MEMORANDUM

RE: Resubmission of COFA-8-16-9998 (7 Johnston Way)

> **COFA-08-16-9998.** A Certificate of Appropriateness to permit the construction of a two story mixed-use commercial structure of approximately 5,000 SF on the property located at 7 Johnston Way within the Bluffton Village Development, and zoned Bluffton Village PUD.

2 A1.2 PROPOSED ROOF PLAN
SCALE: 1/4"=1'-0"

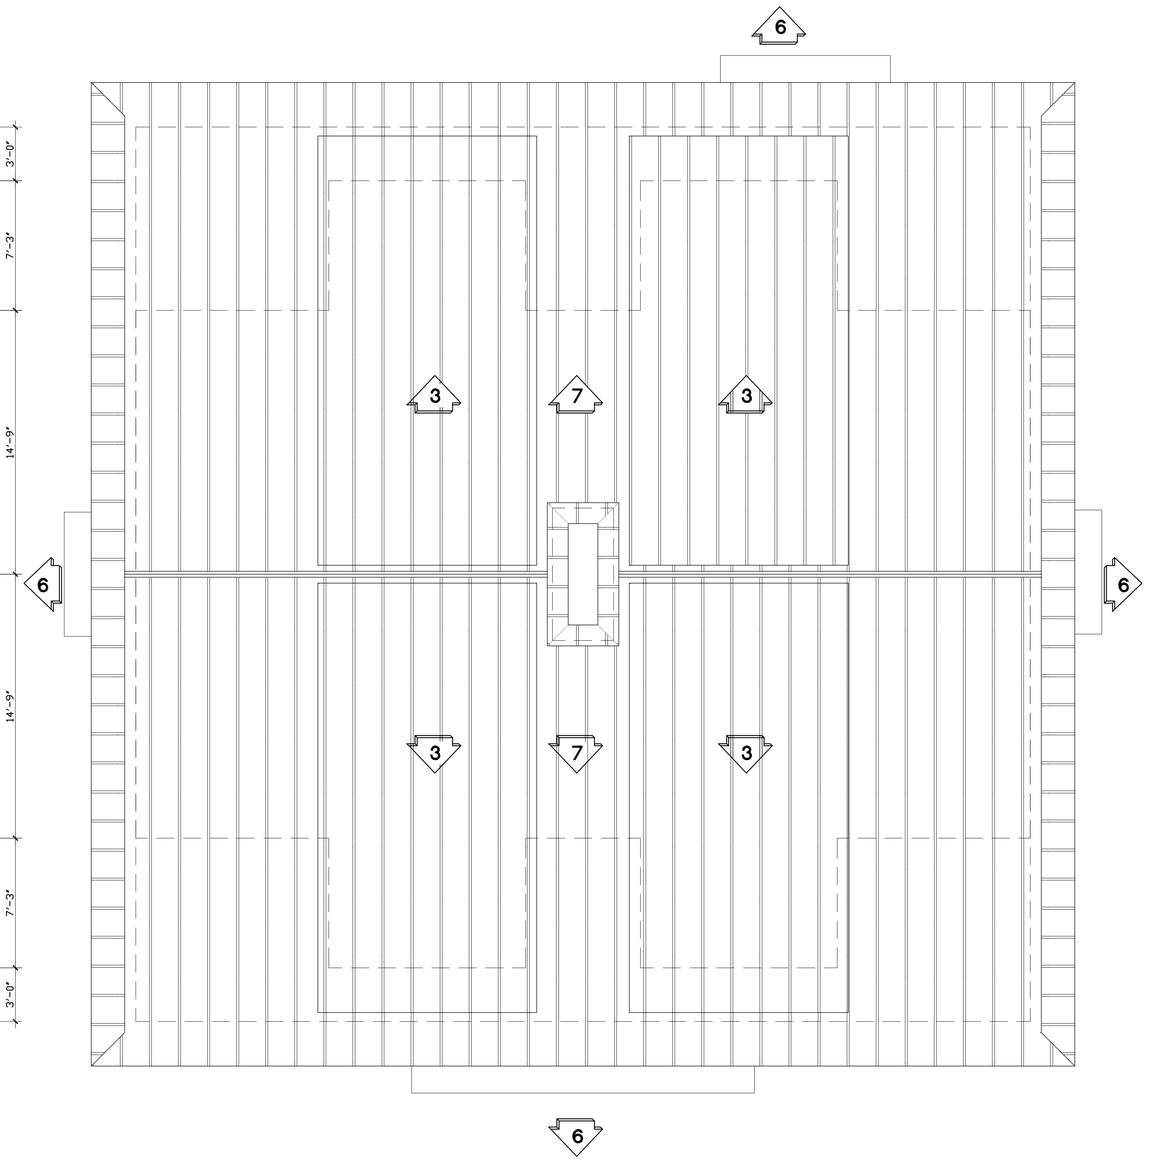
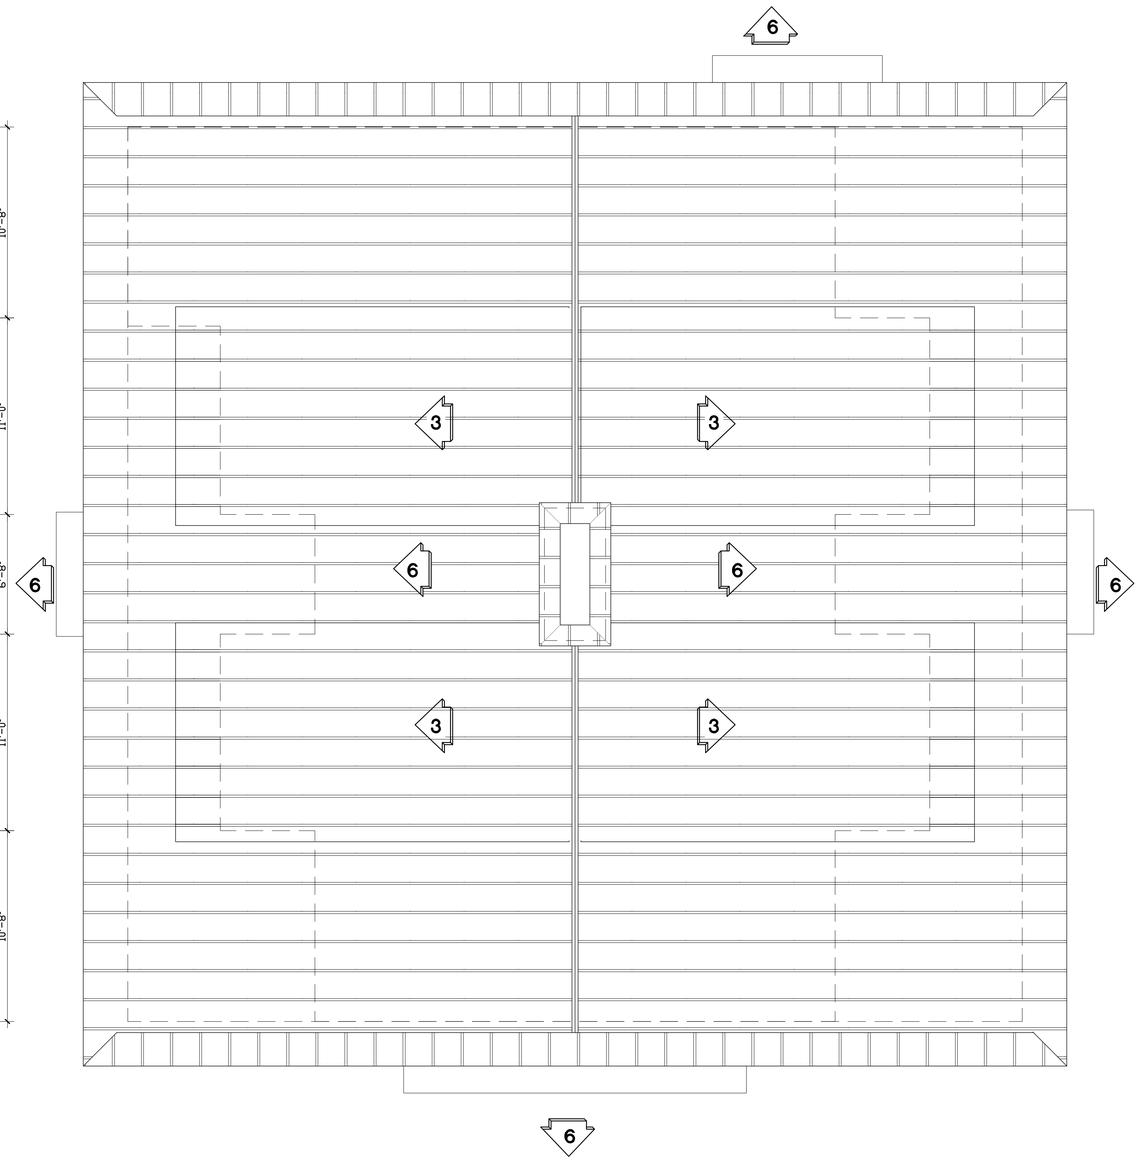
3. Rotate the roof
4. Add windows on the first floor
5. Change out some trees
6. Adjust the mullions

1. Overall building height was reduced from 43 feet to 38 feet;
2. The height of the chimney was reduced from 49 feet to 42 feet;
3. The roof was rotated;
4. Windows on the first floor and dormers were revised;
5. A dumpster enclosure was included;
6. Porch columns were added on the West Elevation;
7. The landscaping plan was not changed;
8. The depth of the porch was not changed from the 6 feet as previous shown;
9. The plans still notes the use of tabby stucco; and
10. The applicant has stated that they have reached out to the POA/ARB to provide an updated approval based on the changes. Once received staff will forward to the Board immediately.

3 A4.0 SERVICE YARD DETAIL
SCALE: 1" = 1'-0"

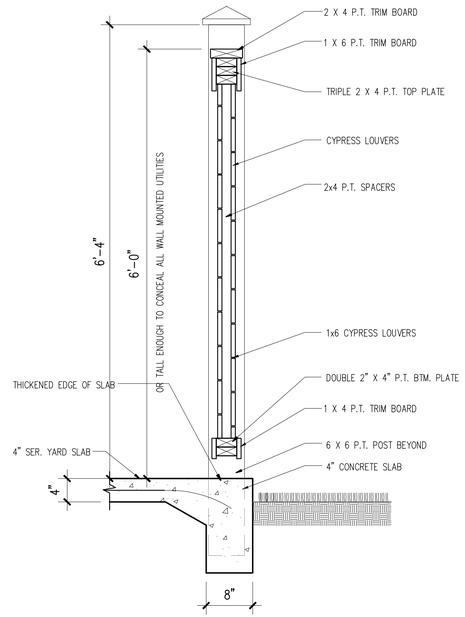
requirements. Provide additional information on the typical dumpster enclosures.

requirements. Provide additional information showing how any outdoor equipment or trash receptacles will be screened.

1 A4.1 DUMPSTER ENCLOSURE PLAN
SCALE: 1/2" = 1'-0"

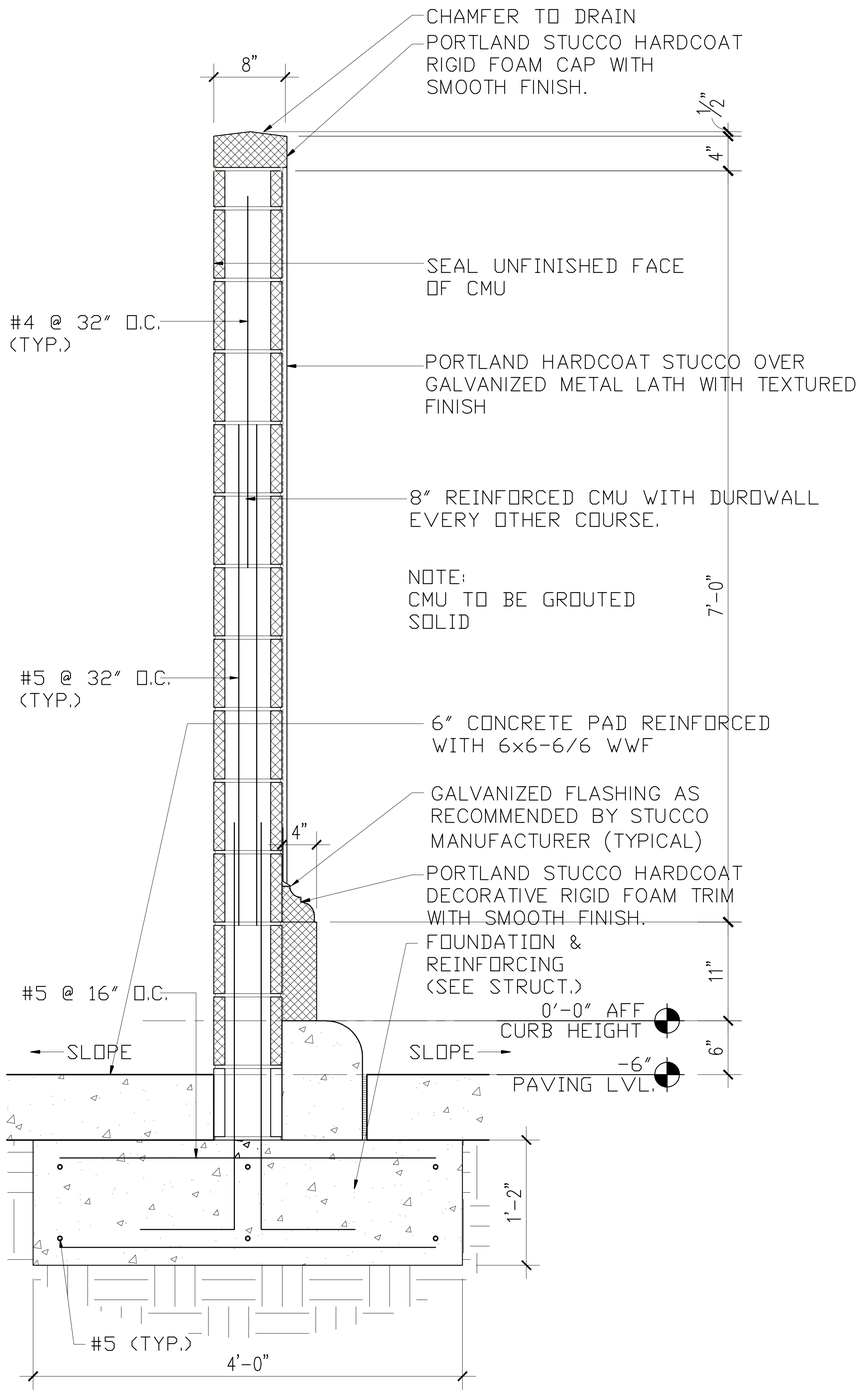
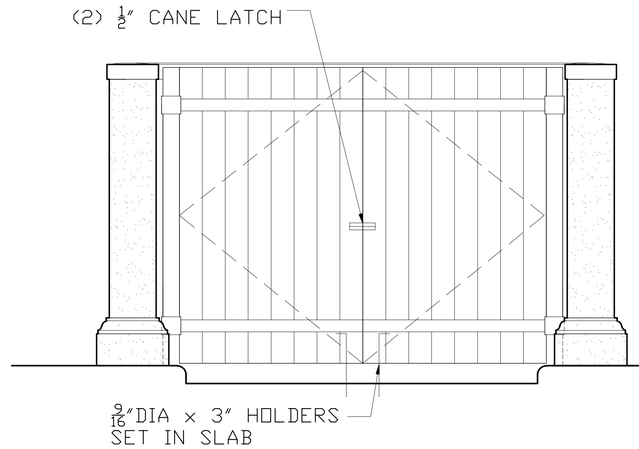
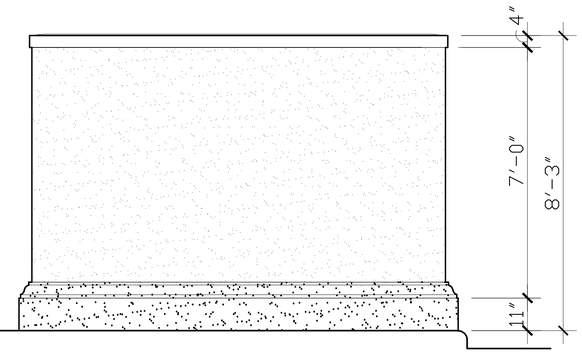
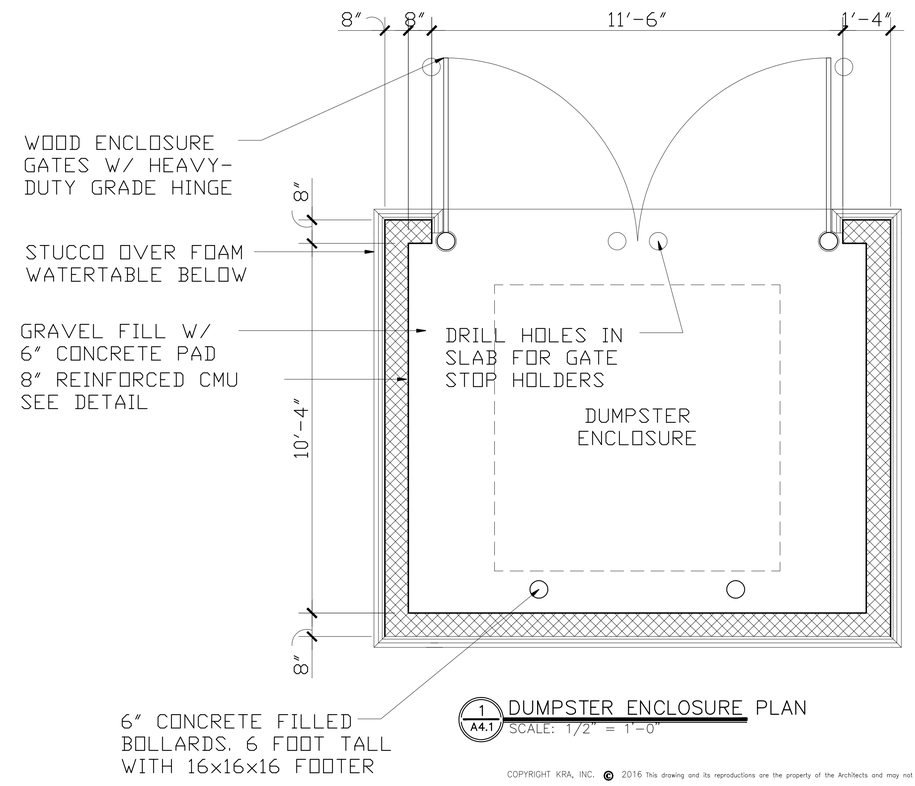
5) *Finding –Other Requirements.* Section 5.15.12. of the TOB-ZO states that all trash receptacles, dumpsters, ductwork, fixed operating machinery, and other such utility equipment shall be either screened from view or located so that they are not visible from the highway. There was a dumpster pad installed as part of the development plan. Not enough information was provided regarding the site accessory structures (i.e. dumpster enclosures, grease traps, etc) to determine if they meet the

WINDOW D
- VINYL CLAD PICTURE AND IMPACT PANEL PROTECTION PER 1609.1.2.
- PROVIDE LOW-E, CLEAR GLAZING.

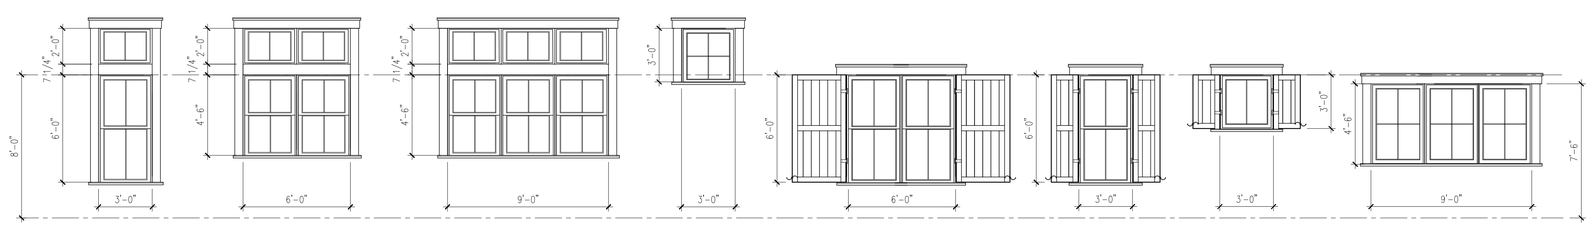
2. Architecture
    a. Per Section 5.15.9.E.4. of the TOB-ZO, the Window D on the West Elevation must be revised to have a consistent window pane pattern.
